**Medway DPW Water Quality Treatment  
Facility Site Plan – 19 Populatic Street**

**SUBJECT: Populatic Water Treatment Plant – Major Site Plan Review  
19 Populatic Street, Medway, Massachusetts**

Wright-Pierce has received Tetra Tech's comments on the Major Site Plan Review submission for the Populatic Water Treatment Plant project. We have prepared the following letter and attachments in response to these comments.

DRAWING  
C-1

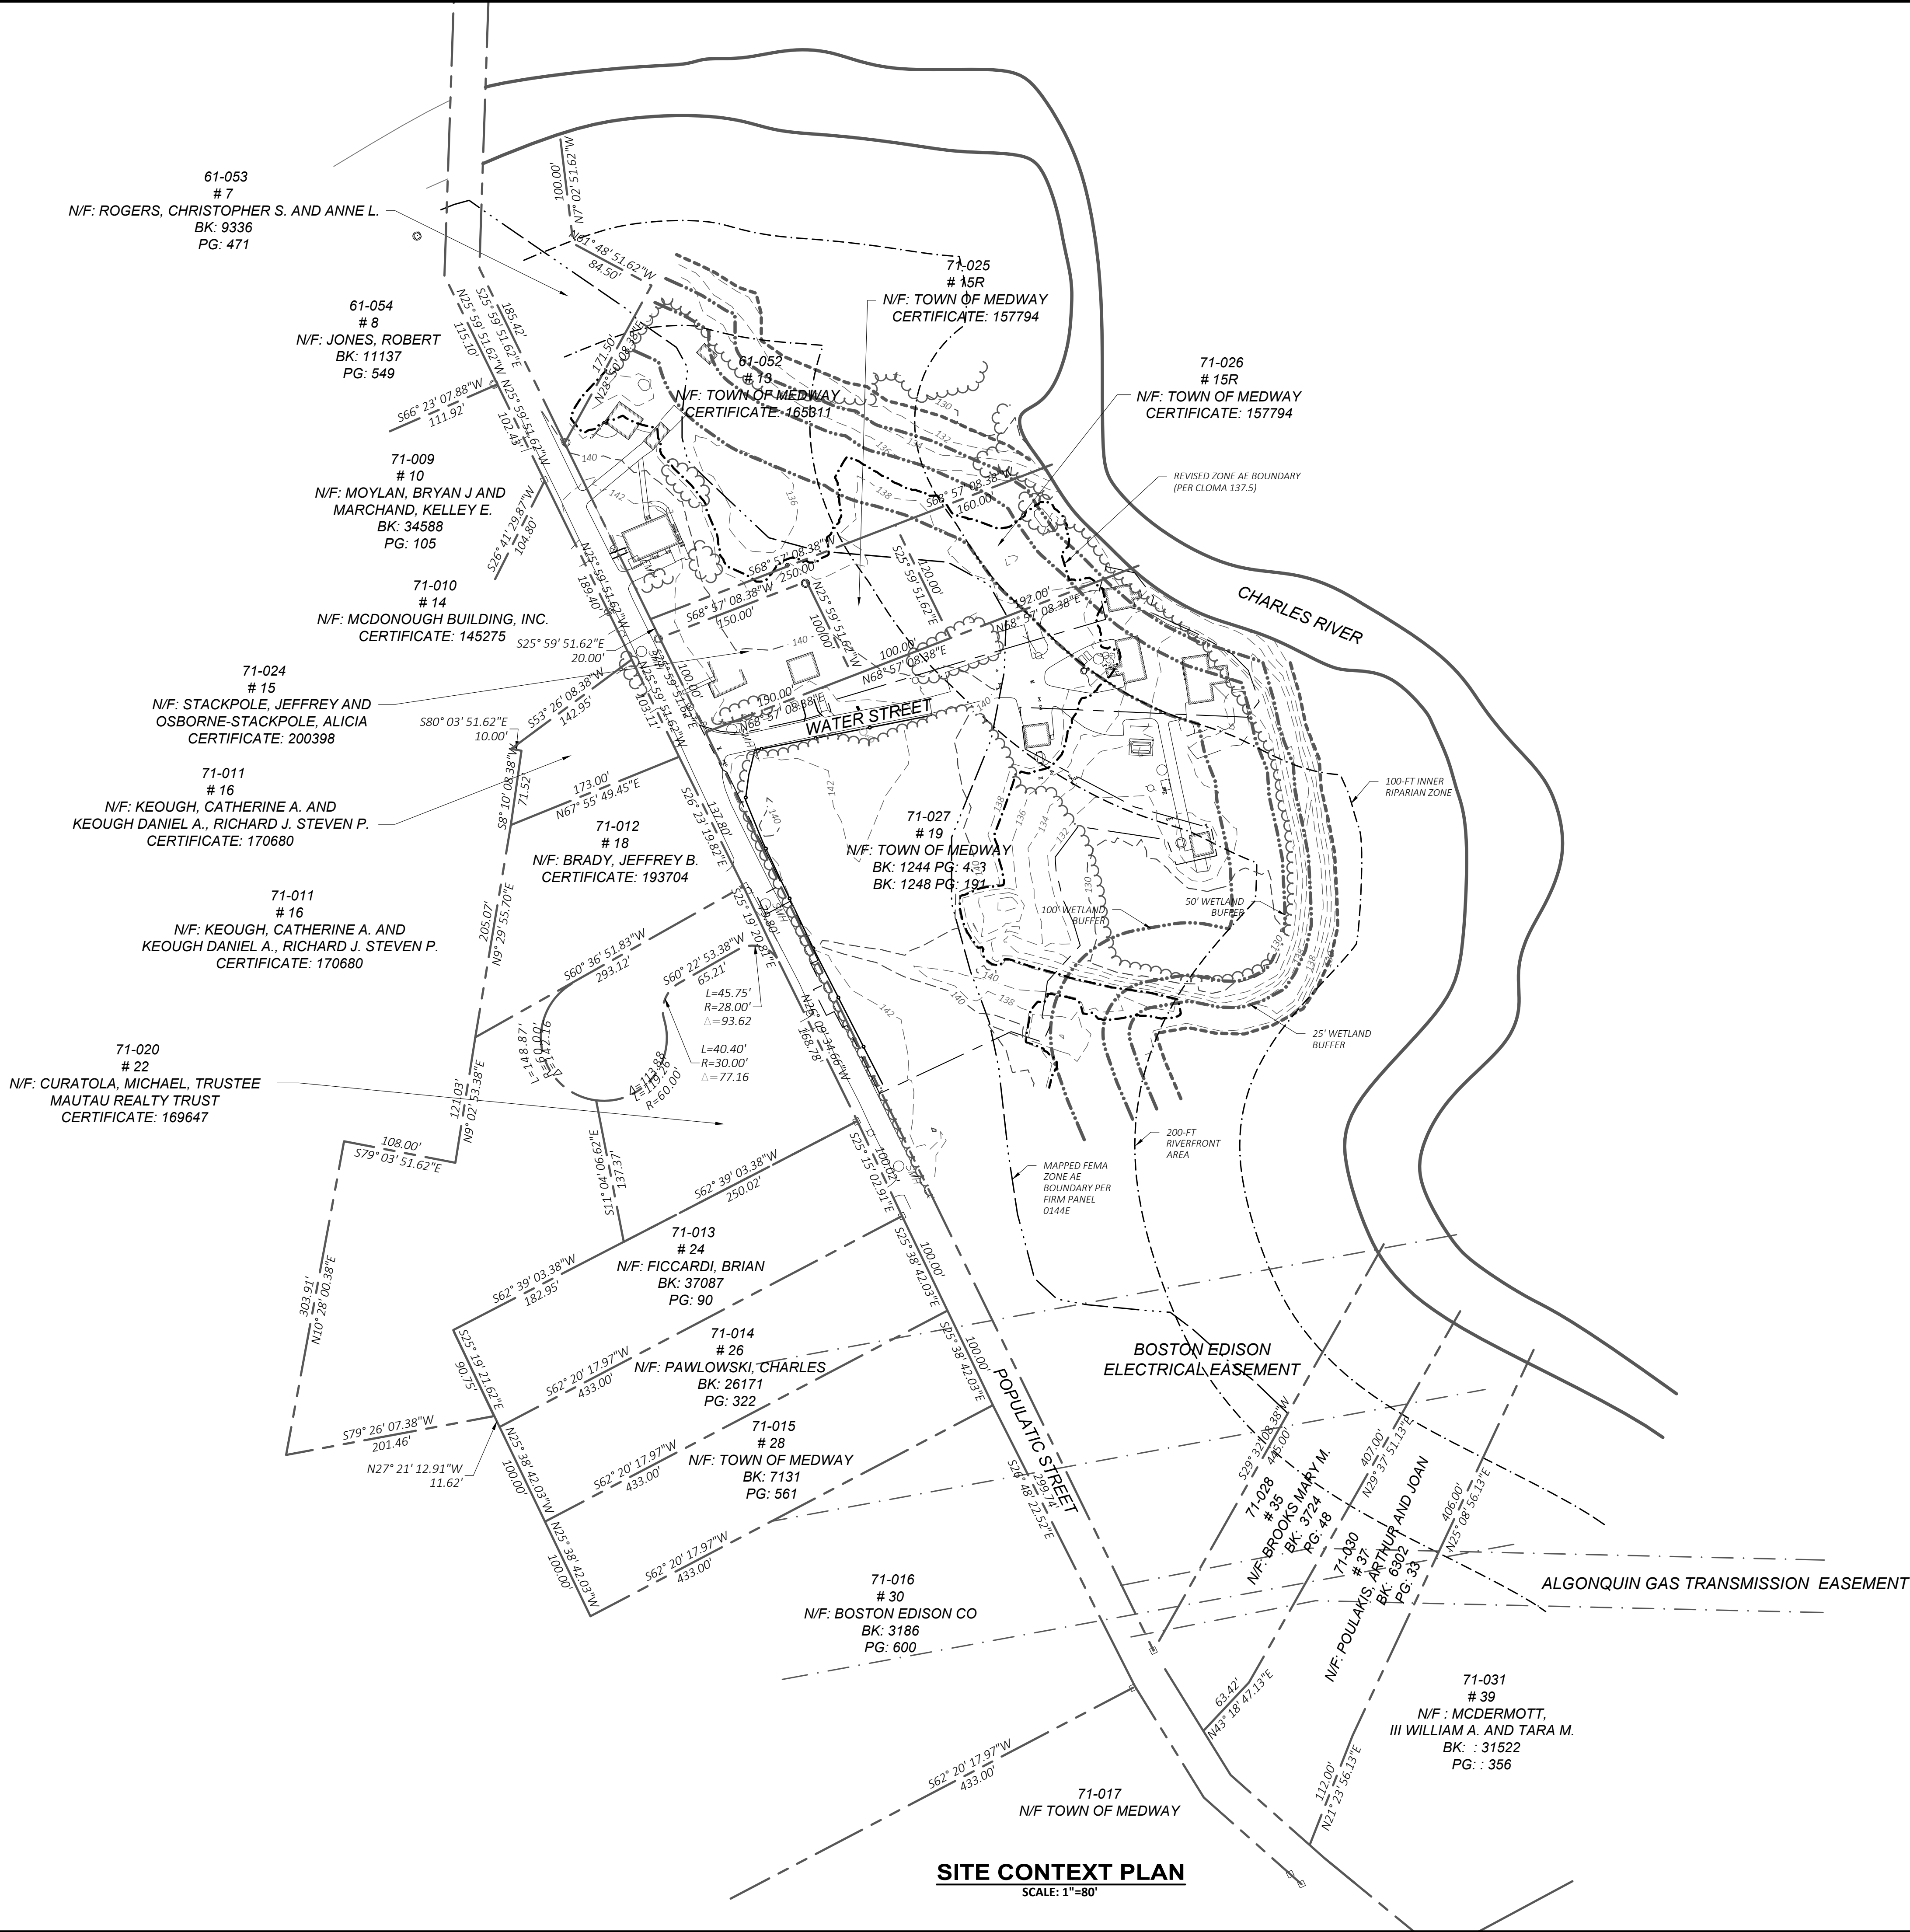
6. All elevations in the Plans refer to the NGVD29 Datum. Elevations shall refer to North America Vertical Datum of 1988 (NAVD88) as specified in the rules and regulations (Ch. 200 §204-4.C)

***Response: The reference to NGVD29 Datum on the plans is incorrect. The design elevations depicted on the plans are in the correct NAVD88 datum. Civil Site Layout Note 11 on drawing C-1 has been updated in the revised set of drawings to reflect the correct datum. Refer to Attachment C.***

DRAWING  
C-1A

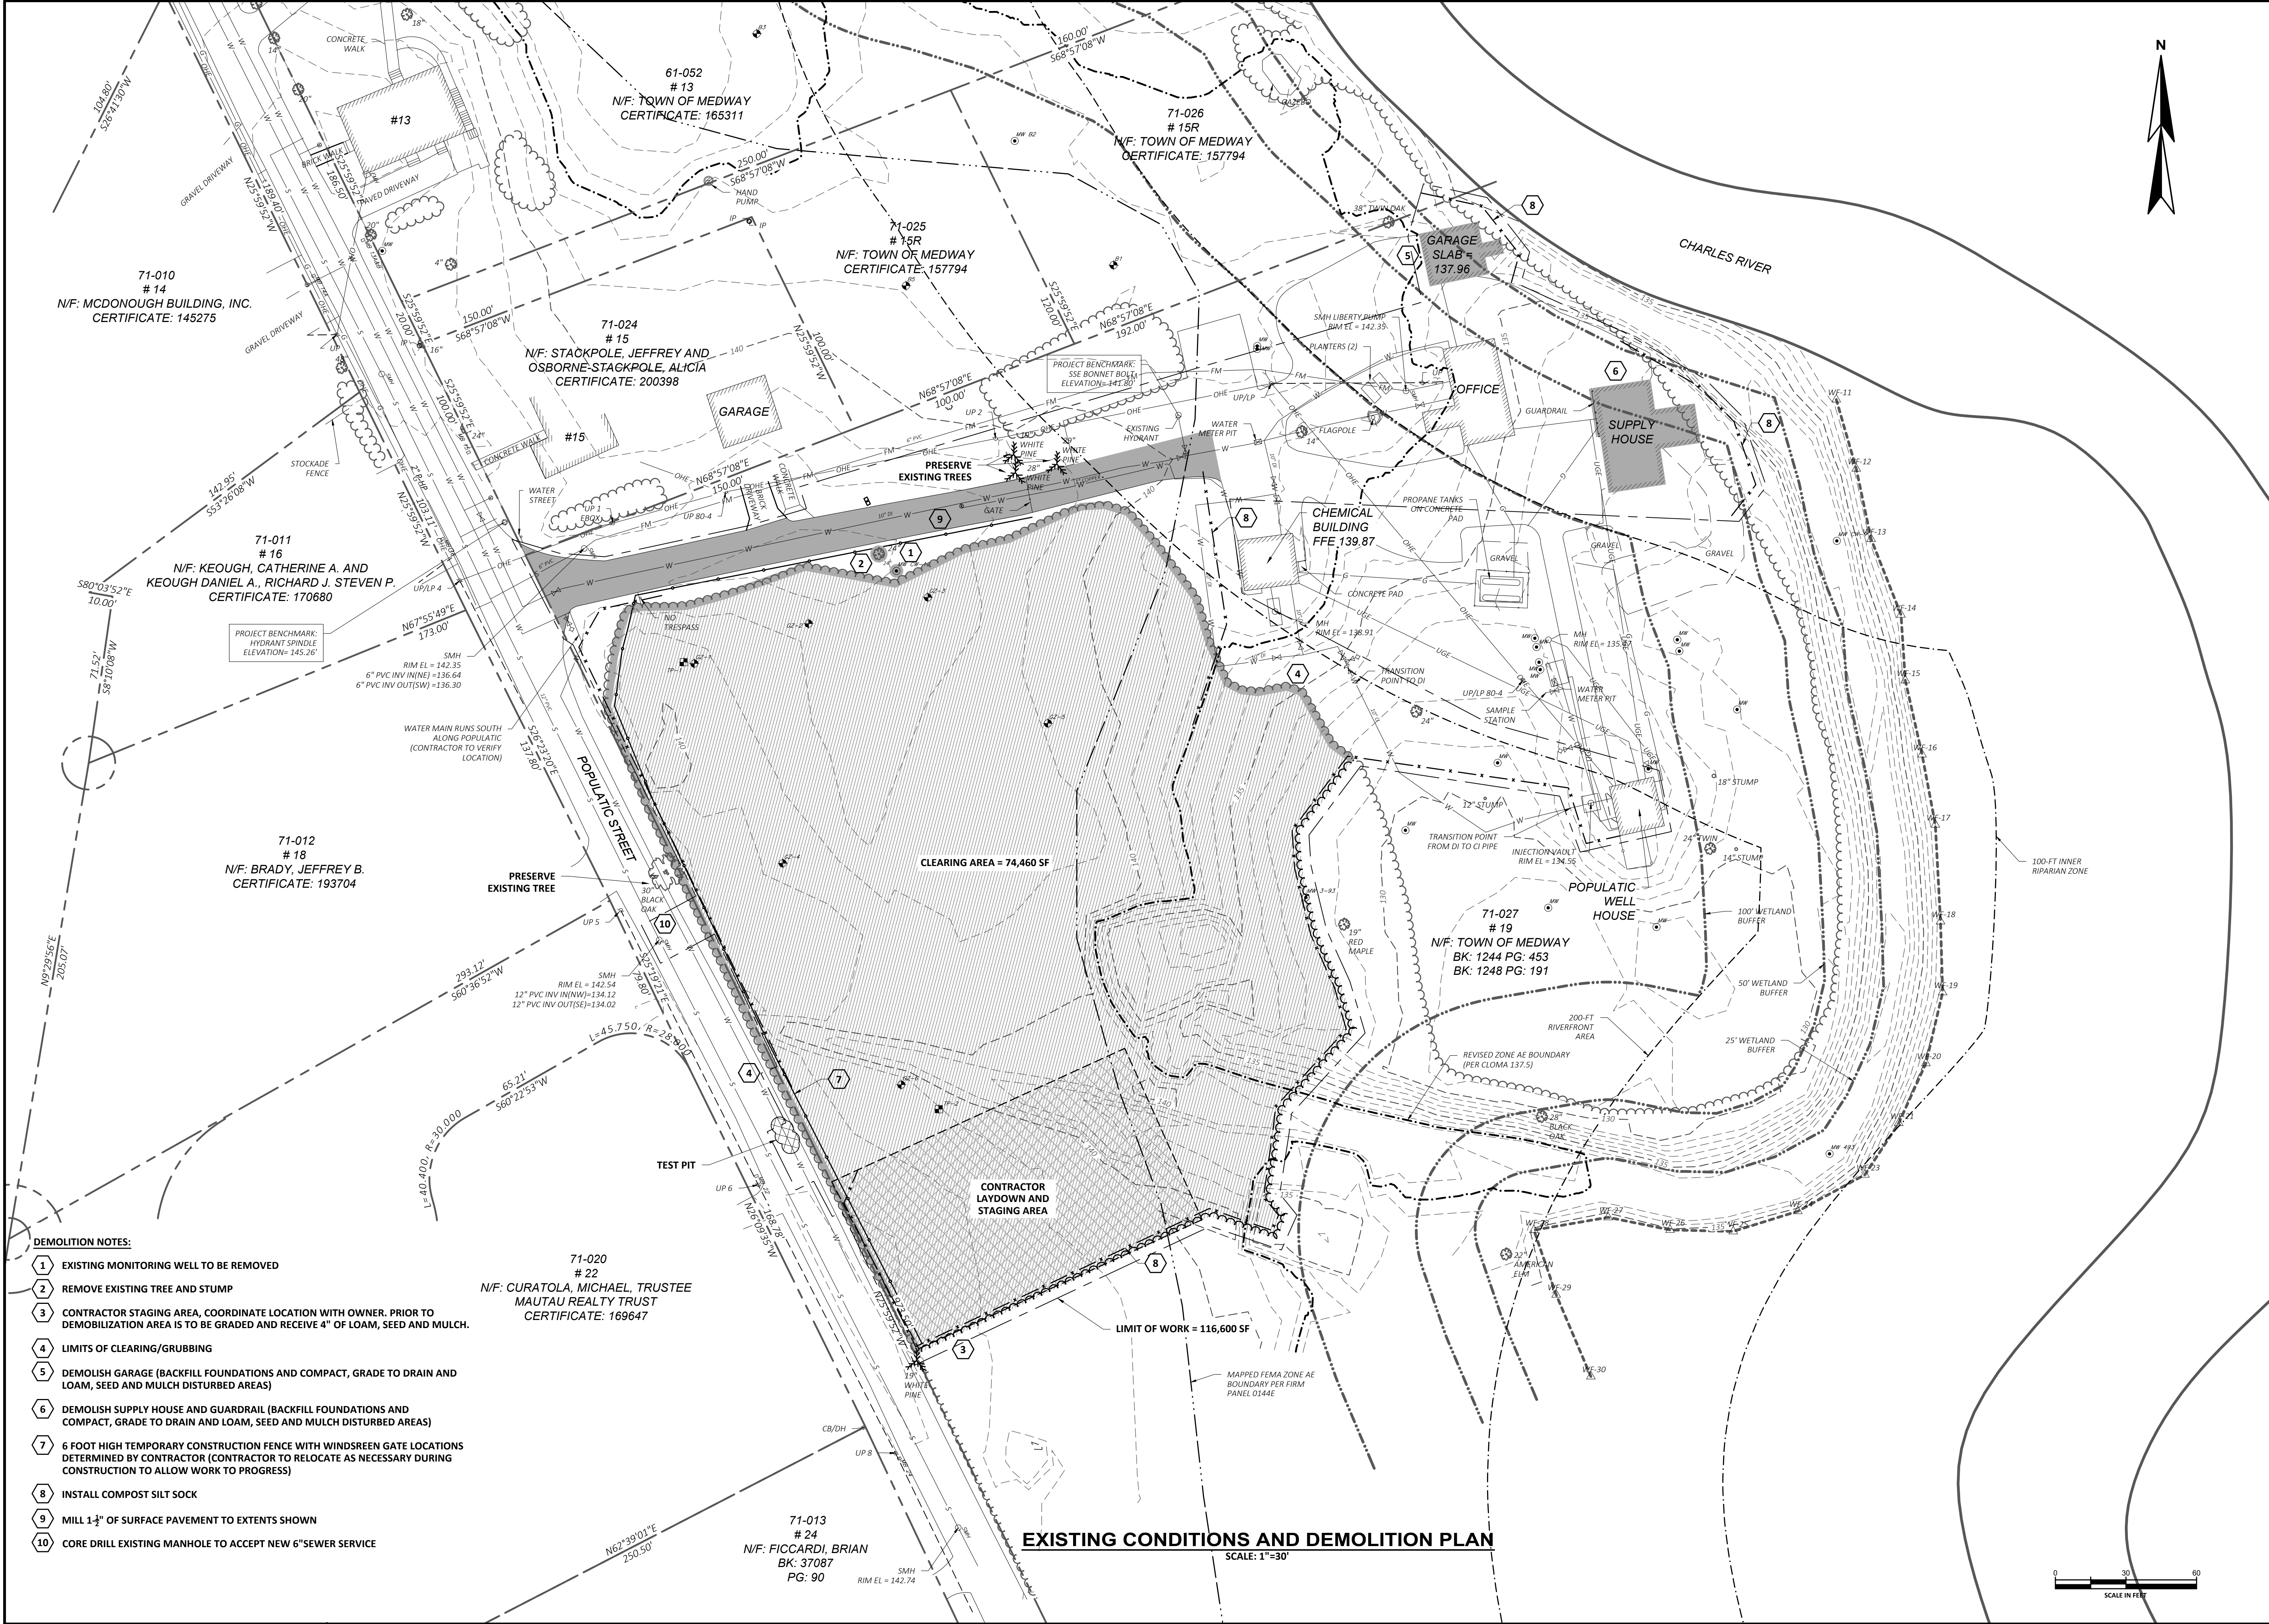
7. A locus map is included on the Cover Sheet and no formal Site Context Sheet has been provided. The scale of the locus map is set to 1-inch equals 2,000-feet which does not meet the maximum required scale of 1-inch equals 1,000-feet. A Site Context Sheet shall be provided per the applicable Regulation. (Ch. 200 §204-5.B)

***Response: A Site Context Sheet has been added to the revised plan set as drawing C-1A. Refer to Attachment C.***
